Public Hearing Ord 2022-XXX PDD-15-01(B)

5818 S Old Bastrop Hwy / Trace PDD Amendment #2

Hold a public hearing and consider a request by Caren Williams Murch, on behalf of Highpointe Trace, LLC., to amend the regulations and standards applicable within the Trace Planned Development District (PDD) consisting of approximately 417.63 acres of land generally located at 5818 South Old Bastrop Highway, to, among other things, update provisions concerning document illustrations, the zoning concept plan, public space, circulation and connectivity, site design, architectural design, signage, and appendixes.

Illustration 7, Concept Zoning Plan

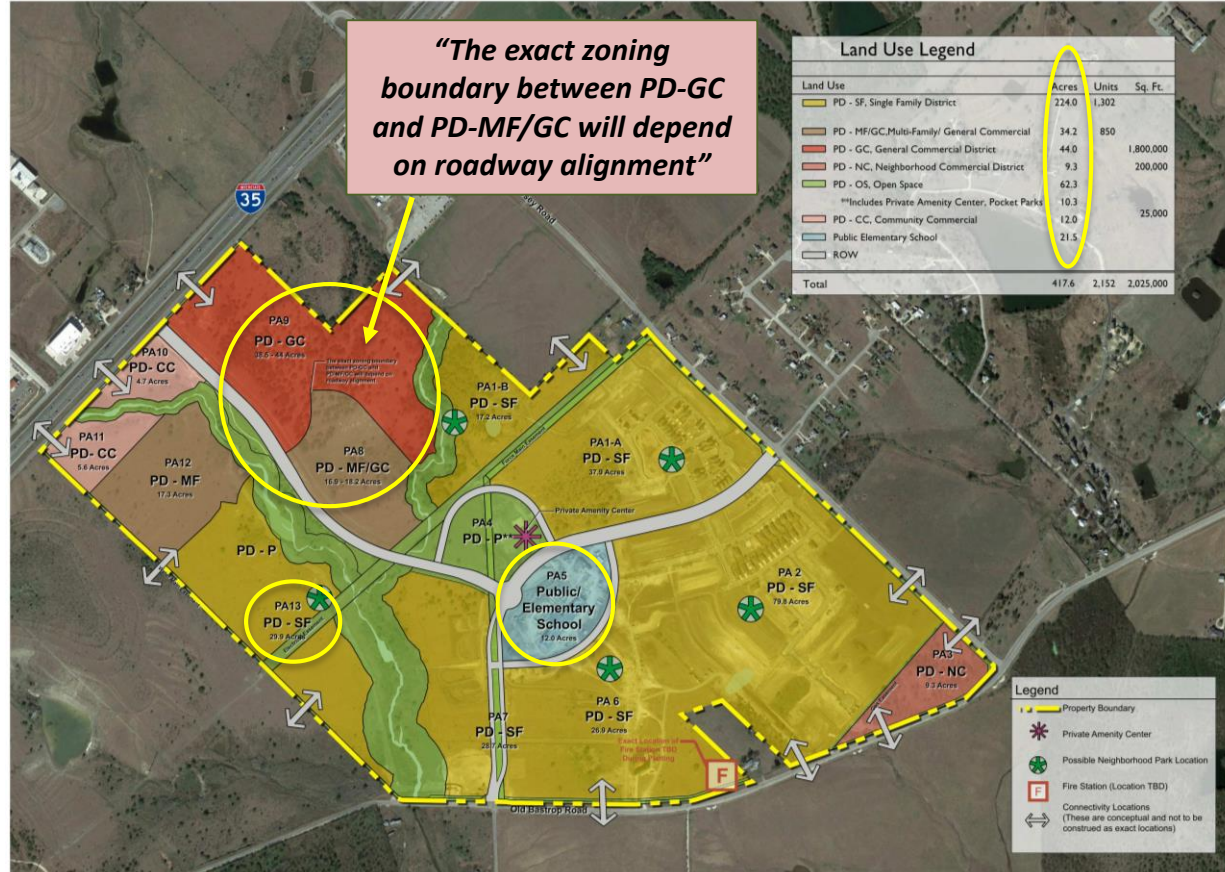
- Provided additional flexibility between PD-GC and PD-MF-GC due to continued conversations regarding roadway alignment
- Combined “13A” and “13B” into “13” for simplicity
- Slight updates to total acreages of land uses to reflect phasing and survey/platting configurations
- Updated labels

p.23 *Section 3.3.2, Neighborhood Parks*

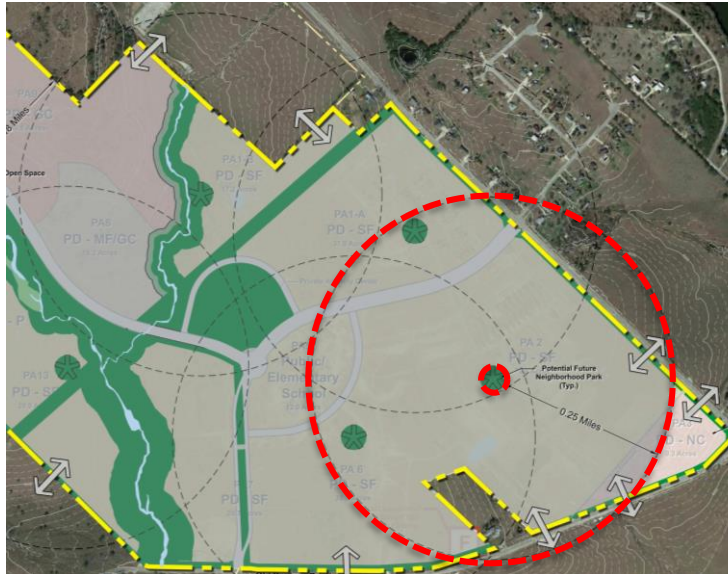
Purpose: Rename “Pocket Parks” to “Neighborhood Parks”

p.27 *Illustration 16: Vehicle Circulation Plan*

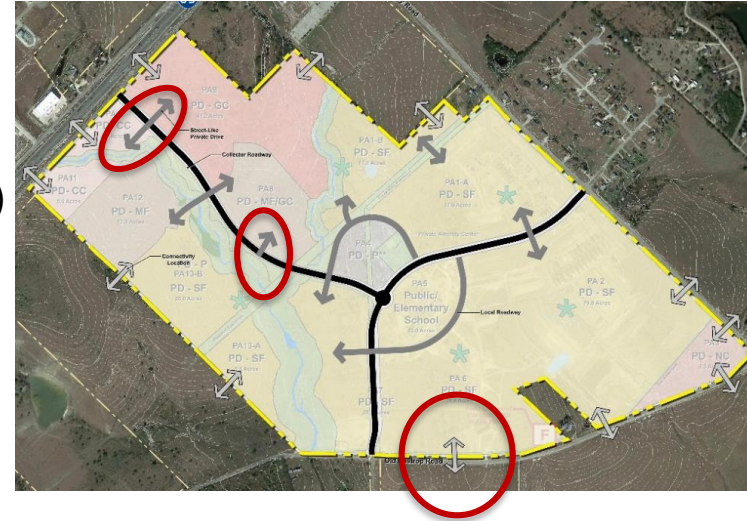
- Added new roadway connection on S Old Bastrop Hwy
- Roadway across creek removed (now a pedestrian bridge)
- Street-like private drive across Van Horn Trace

p.31 *Illustration 18: Key Map to Street Cross Sections*

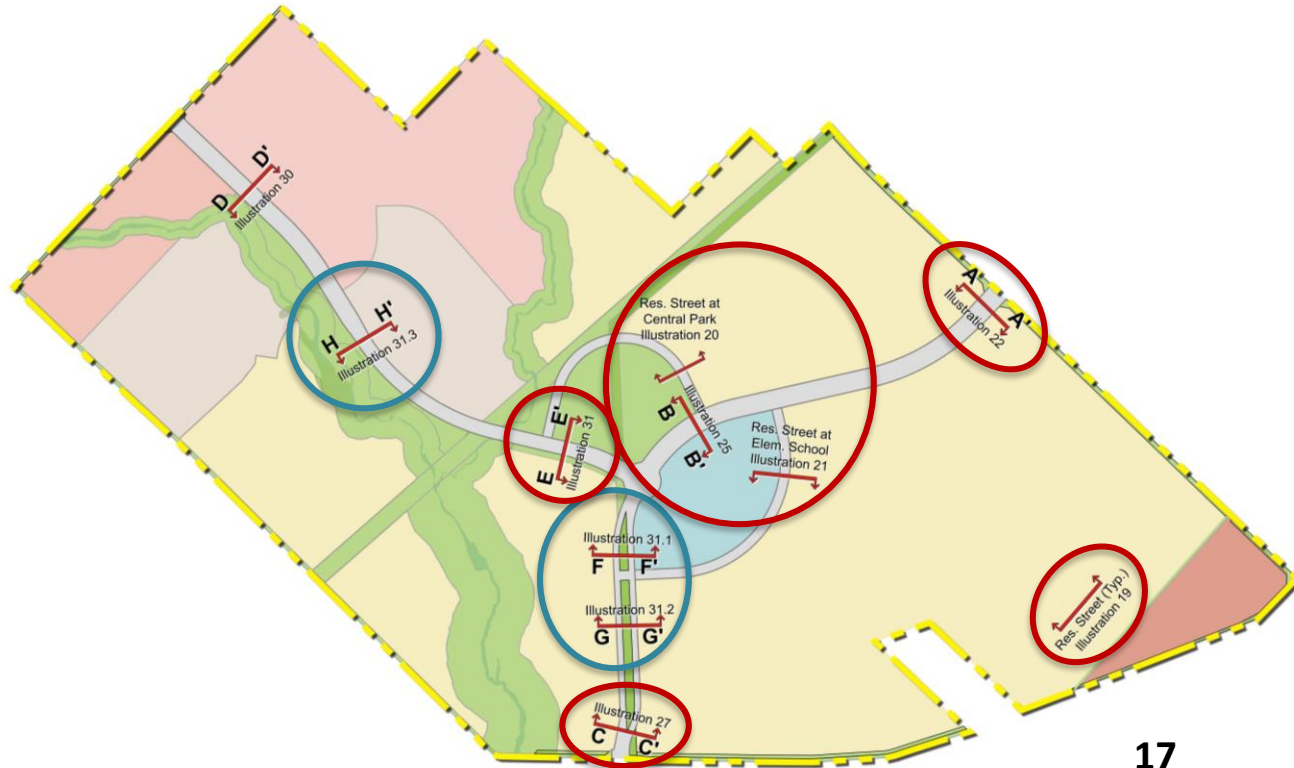
- Updated several existing cross-sections
- Added 3 new cross-sections.
- Purpose for updates is to reflect comments/revisions from the Public Improvement Construction Plan (PICP) permits.

Illustrations 19, 20, 21

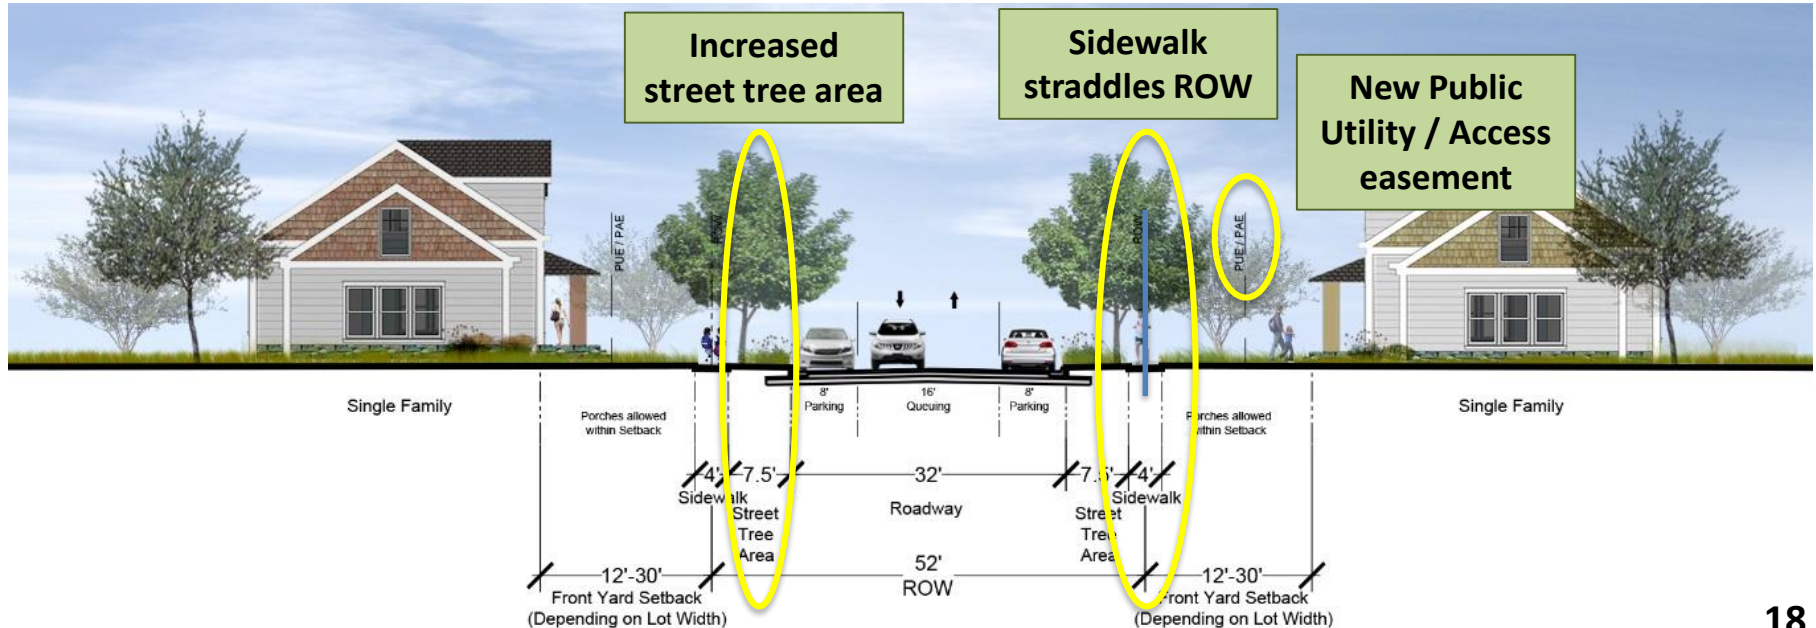
Showing Illustration 19: Enhanced Residential Street (standard) below, however, Illustration 20 and 21 have similar changes

Illustration 22: Enhanced ROW Section AA

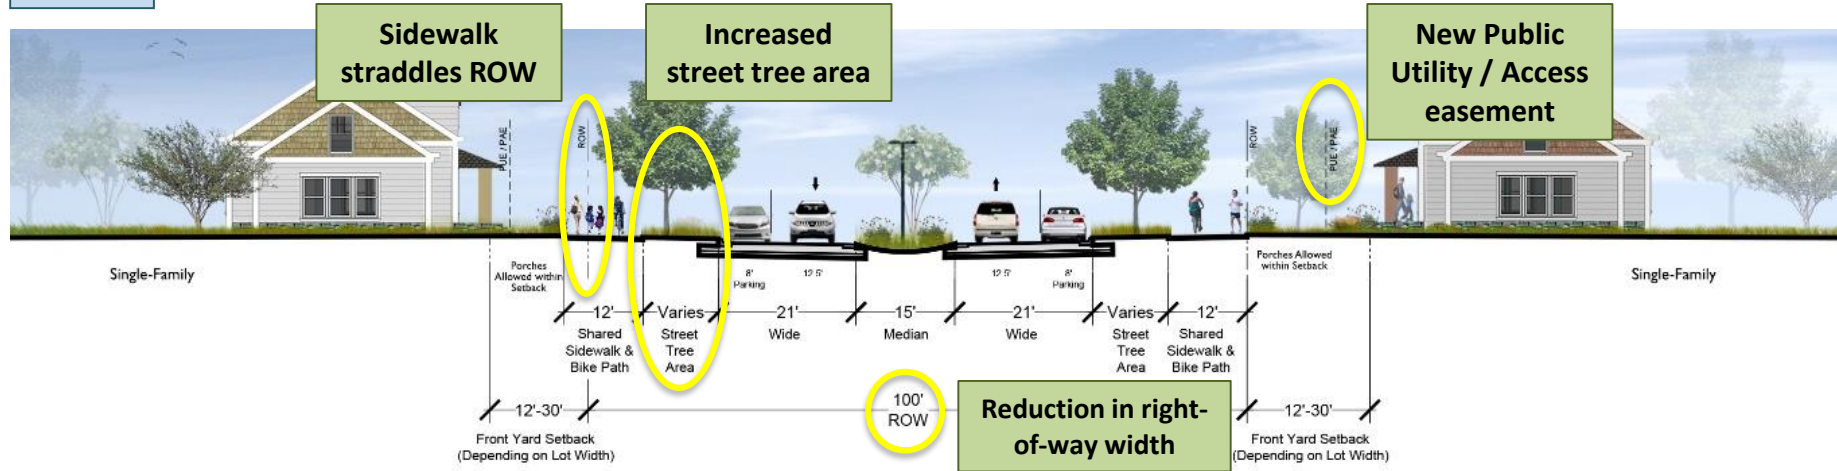
Purpose: More detail added (crosswalks, hardscape, stop bars, etc.) to reflect existing conditions

Illustration 31: Enhanced ROW Section EE

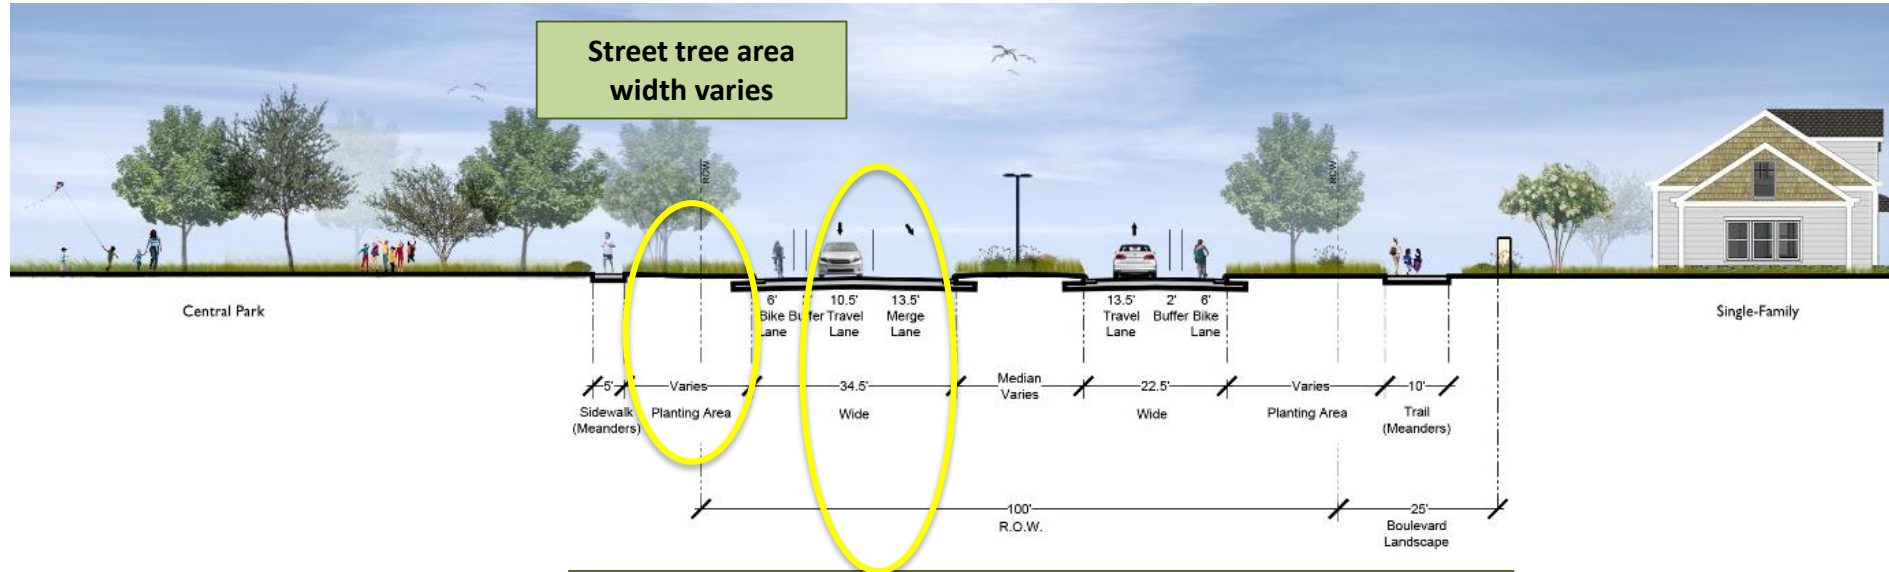
Van Horn Trace reduced from 4 lanes to 2 lanes to reduce speed in residential area. (Remains 4 lane road along commercial sites as reflected in cross-section "DD")

Illustration 31.1: Enhanced ROW Section FF

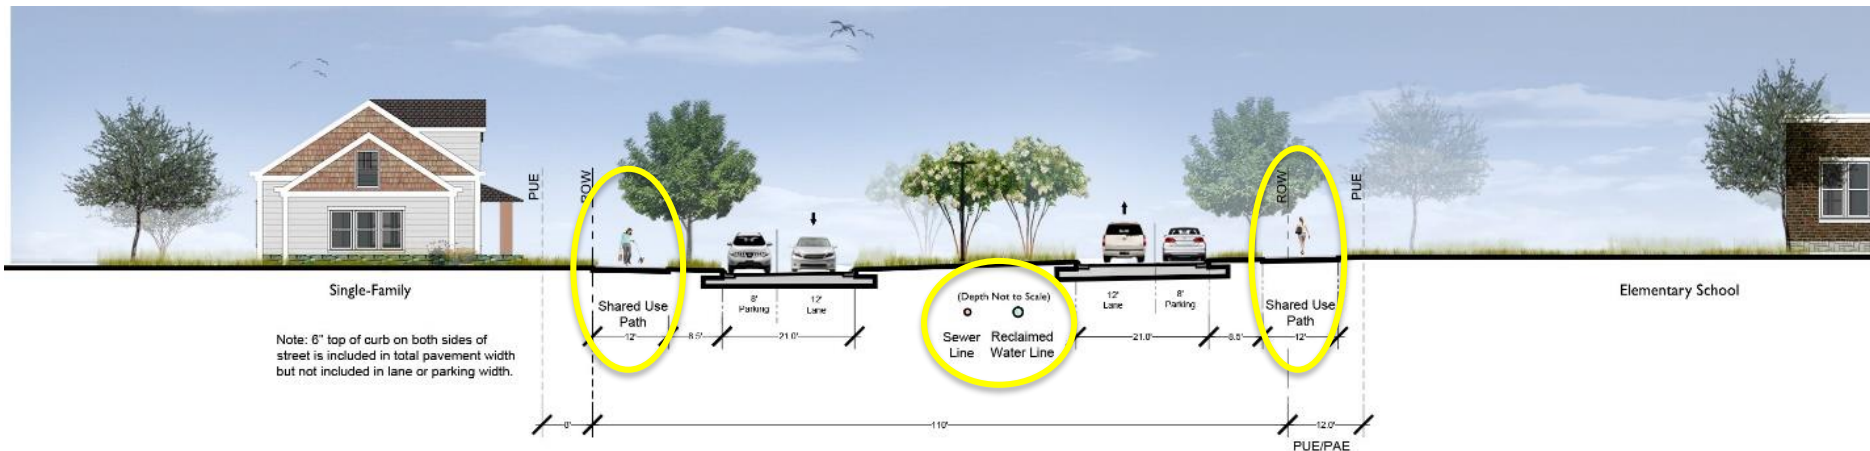
Illustration depicts the new cross-section for Esplanade Parkway (south of the roundabout) as discussed above which include the 12' shared use path on both sides of the street and the location of utilities.

Illustration 31.2: Enhanced ROW Section GG

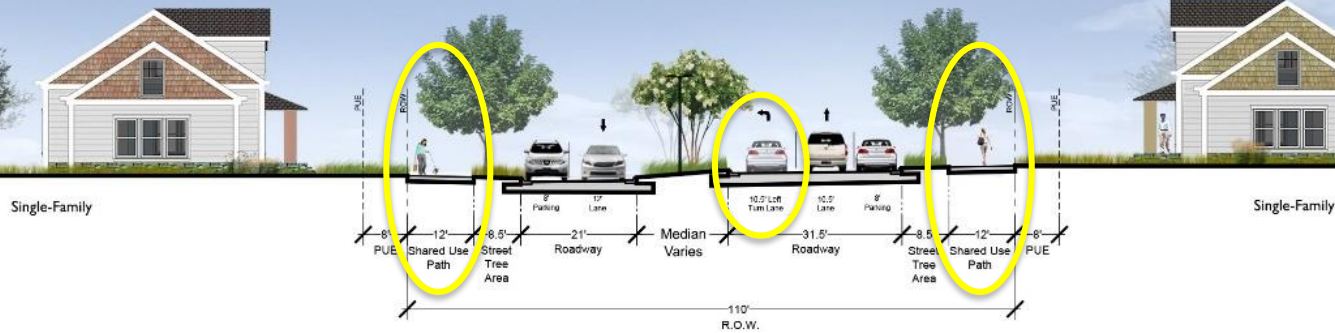
This cross-section is similar to “FF” but it indicates a turn-lane

Illustration depicts the new cross-section for Esplanade Parkway (south of the roundabout) as discussed above which include the 12' shared use path on both sides.

Illustration 31.3, Enhanced ROW Section HH

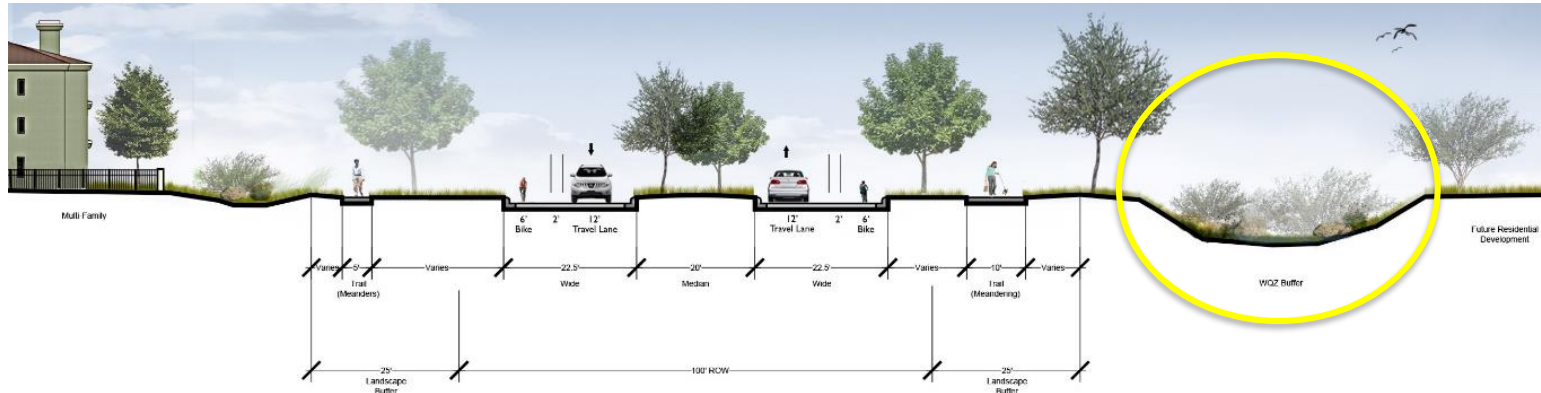
Illustration is identical to existing cross-section "EE" in the PDD but it shows the water quality zone buffer.
